AGENDA
CITY OF KENTWOOD PLANNING COMMISSION
TUESDAY, JULY 27, 2021
KENTWOOD COMMISSION CHAMBERS
4900 BRETON AVENUE
7:00 P.M.

PROPOSED MINUTES OF THE REGULAR MEETING
OF THE KENTWOOD PLANNING COMMISSION
TUESDAY JULY 13, 2021, 7:00 P.M.
COMMISSION CHAMBERS

STAFF REPORT: July 12, 2021
PREPARED FOR: Kentwood Planning Commission
PREPARED BY: Lisa Golder
CASE NO.: 20-21 DMS IPUD

To: Kentwood Planning Department
From: Brad Boomstra, P.E.
City Engineer
Date: July 13, 2021
Re: **DMR Transportation**
4401, 4375, 4251 36th Street SE
41-18-13-400-004, 41-18-13-390-027, & 41-18-13-390-026
Review of Site Plan Received 7-12-2021

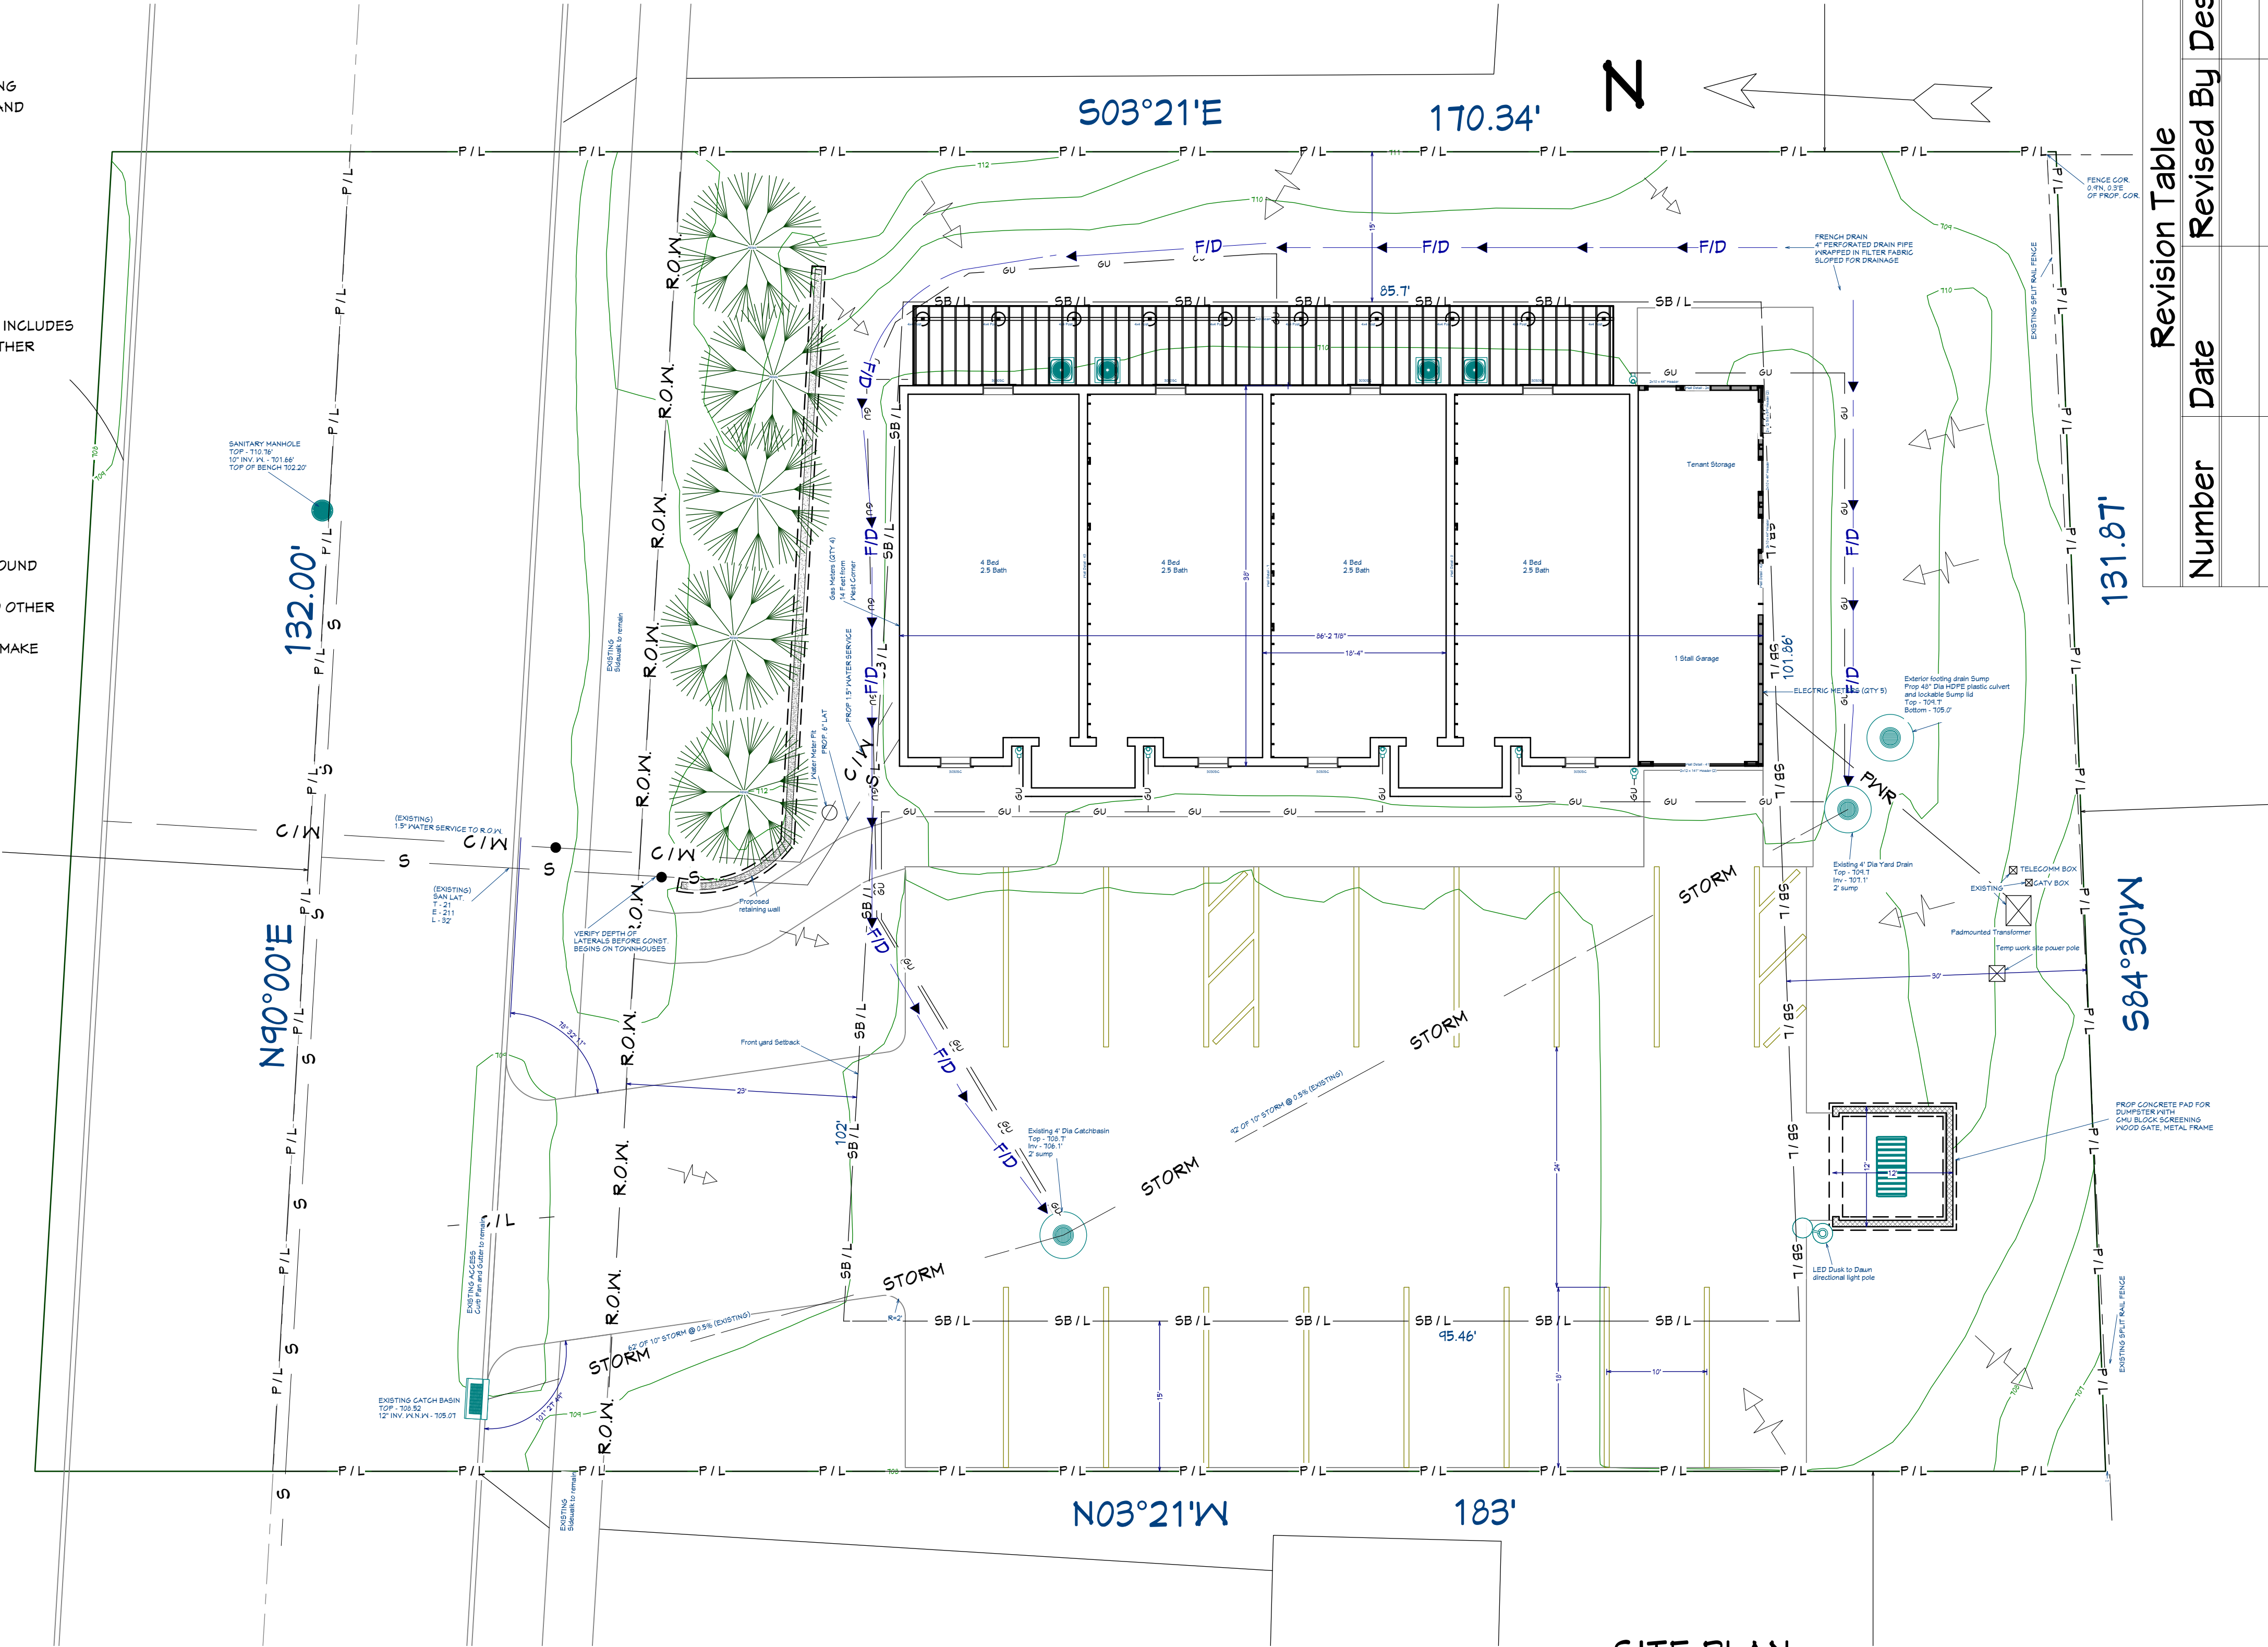
Pung stated section 19 of the zoning ordinance does require a landscape buffer C along the west property line which in this case it is a minimum 10-foot landscape buffer with landscaping. With the proposed development parking would be within 1-2 feet of the property line. He stated they would be installing a 6-foot-high privacy fence. He stated section 19 of the ordinance does allow for a Planning Commission waiver from the landscaping and screening requirements.

1. Staff approval of a landscape plan.
2. Staff approval of a lighting plan.
3. Planning Commission approval of a waiver from the landscaping and screening requirements along the west property line.
4. Compliance with all applicable Engineering Department regulations and requirements
5. Compliance with all applicable Fire Department regulations and requirements.

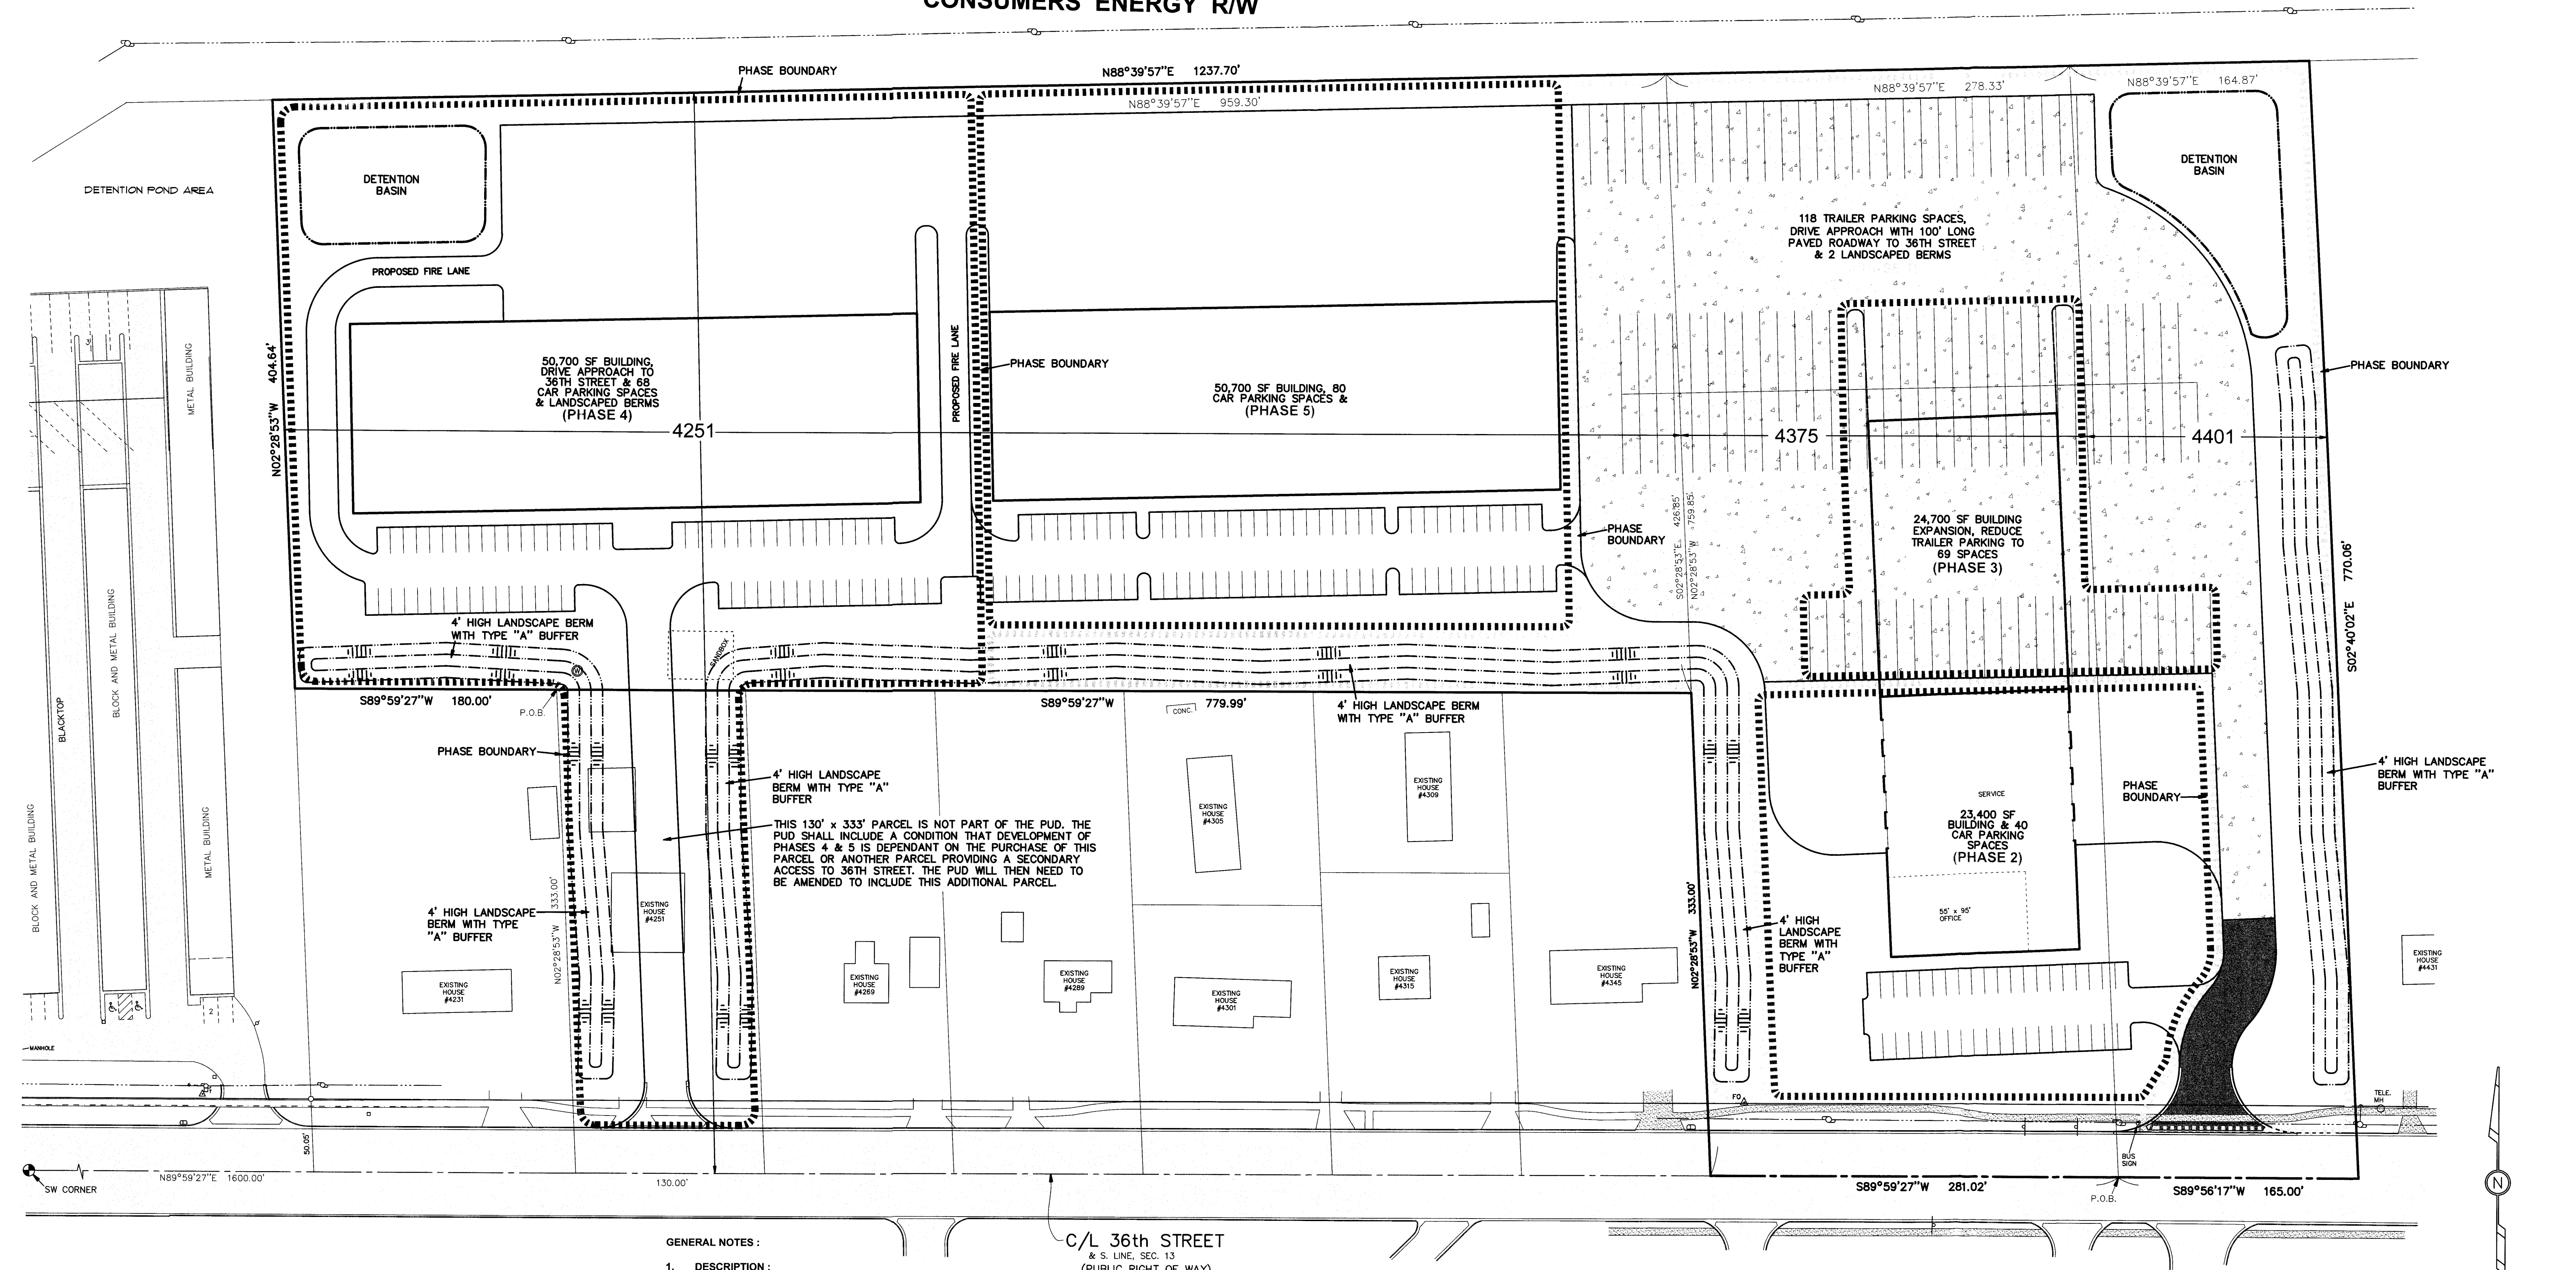
Issues:

- Outdoor vehicle sales not permitted
- Master Plan recommends against motor freight terminals
- Unclear as to why so much trail parking is needed on the site
- Concern regarding impact on residential uses
- Uncertainty regarding future industrial uses to the west
- Development leaves one home between the self storage and the proposed western entry to the PUD development
- Development leaves the secondary access on the west side of the site as residential use; rezoning to IPUD would be required in order to develop the remaining portion of the PUD.
